Strand Lighting

Document : 7Z0046

M24 UPGRADES HANDBOOK

1.1 Tempus M24 Console Motherboard Ref. I832

FIGURE 4.

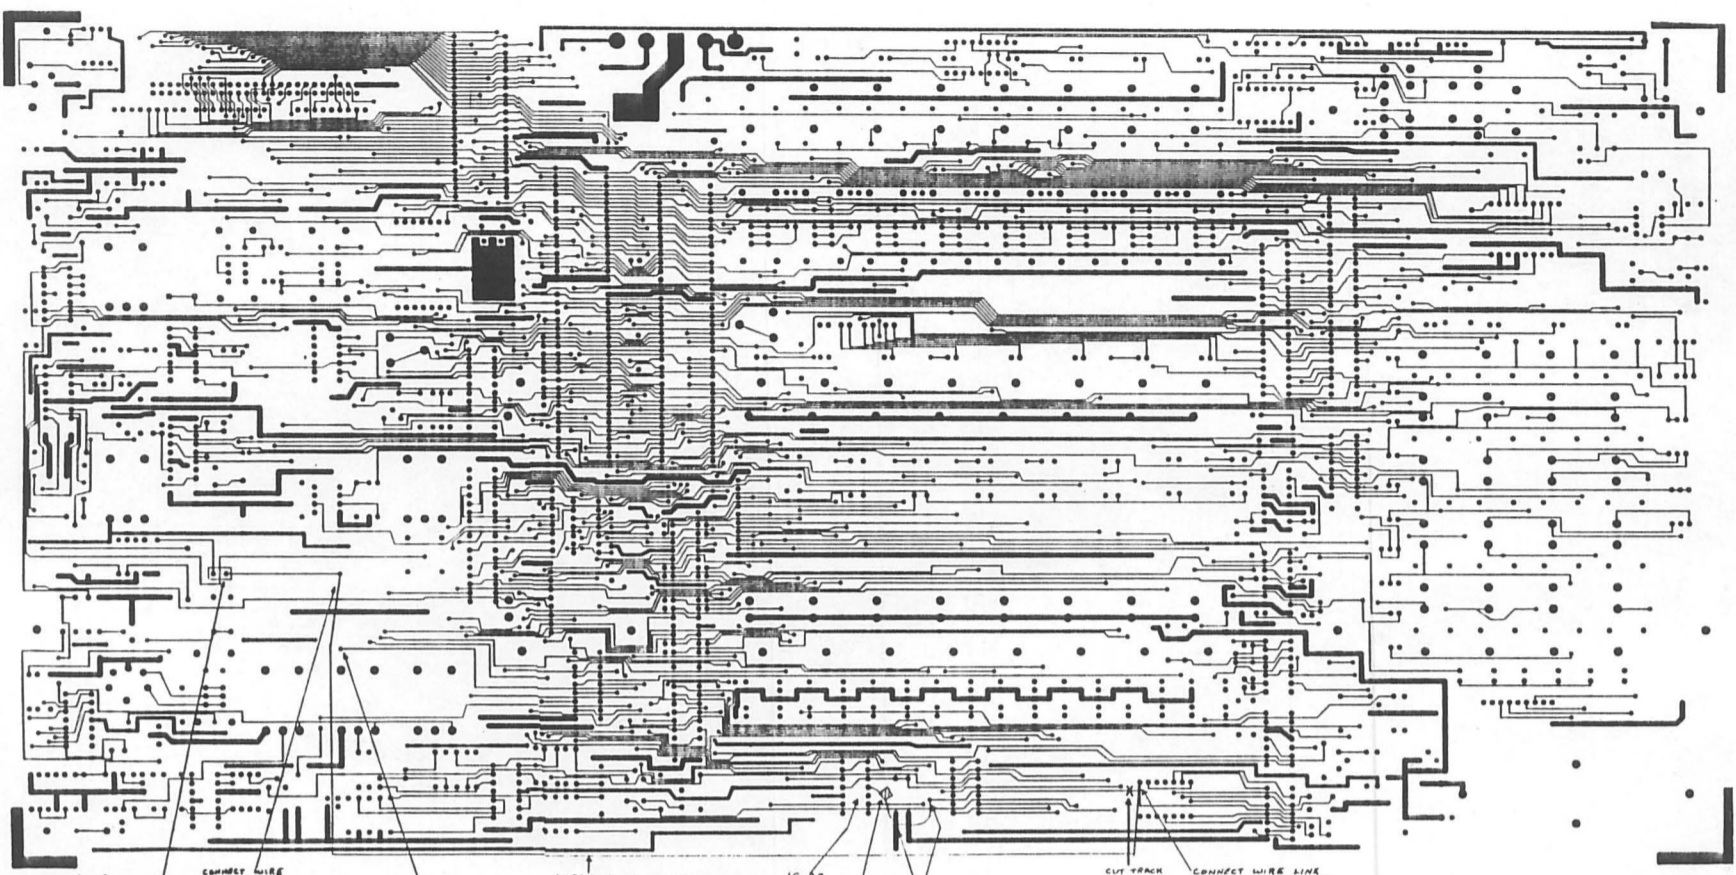
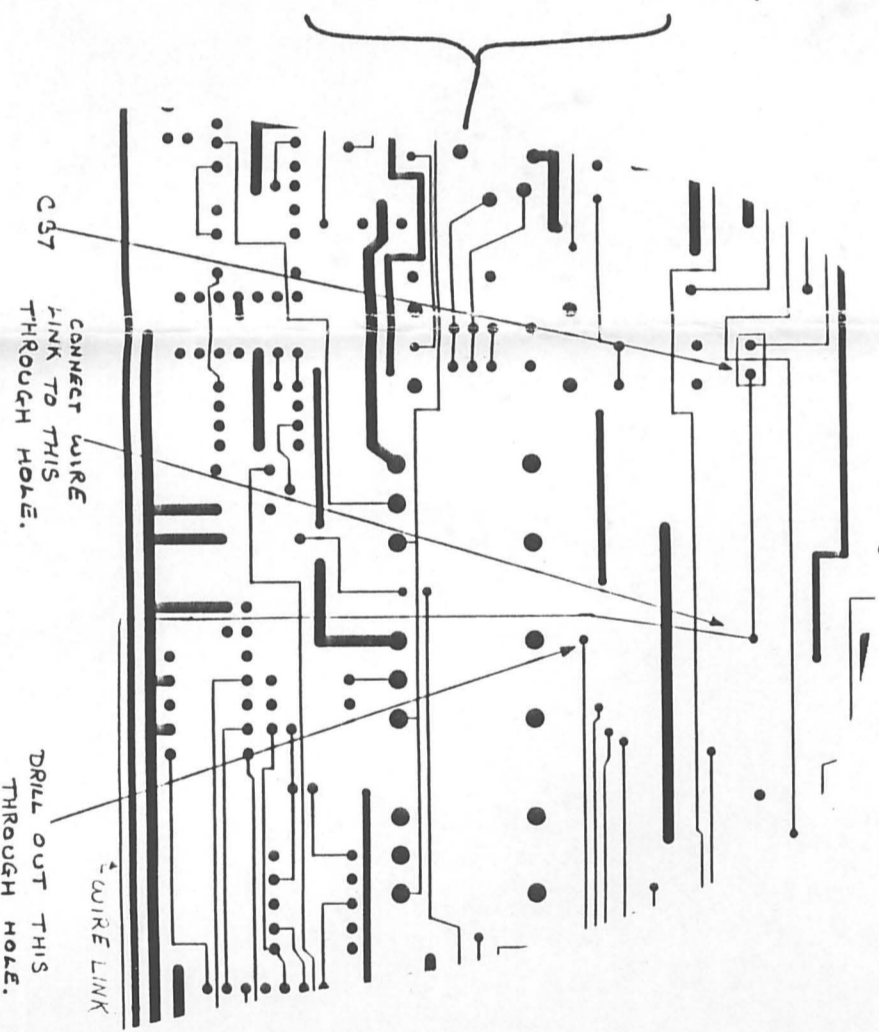
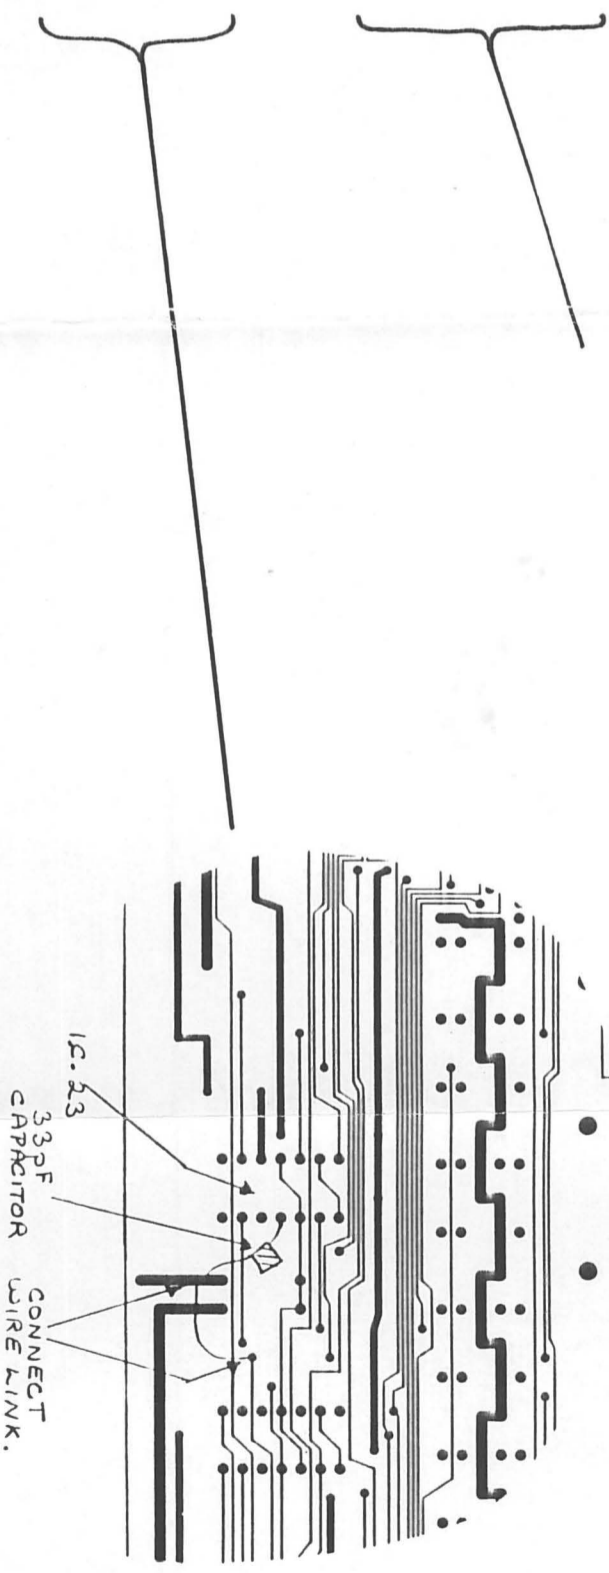
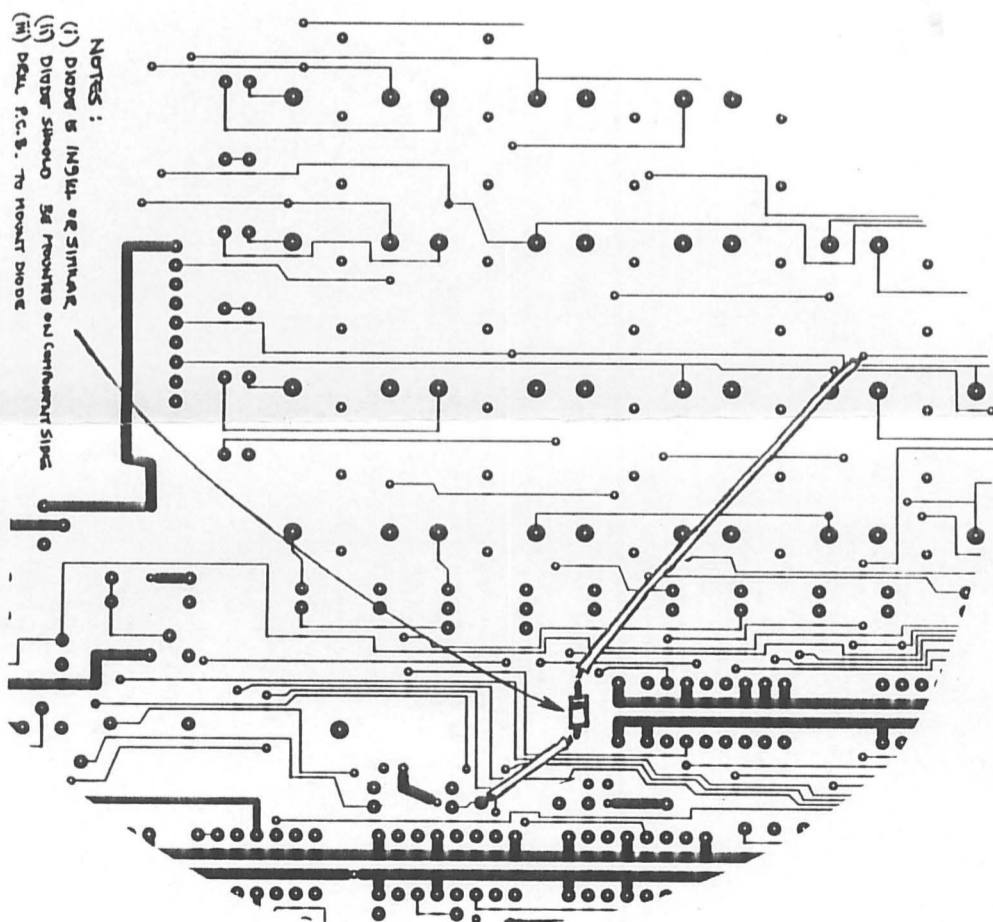
- 1.5.2 Add 33pF chip ceramic capacitor between IC 23/4 and Analog OV (R136). Fit capacitor on component side of P.C.B.

The modification is to suppress noise on the D master.

- 1.5.4 Break track from IC 37/4 by R153. Drill out through hole towards other end of the same track, in the vicinity of RV14. Link this, now isolated, track to Analog OV between IC 23 and IC 24. Connect R153 to track from C37 with a PTFE insulated wire link. 'Tack' the wire link to the P.C.B. at approximately 60mm intervals. Implement modifications on the copper side of P.C.B.

Original track layout gives rise to cross talk between tracks, causing interference on Master H.
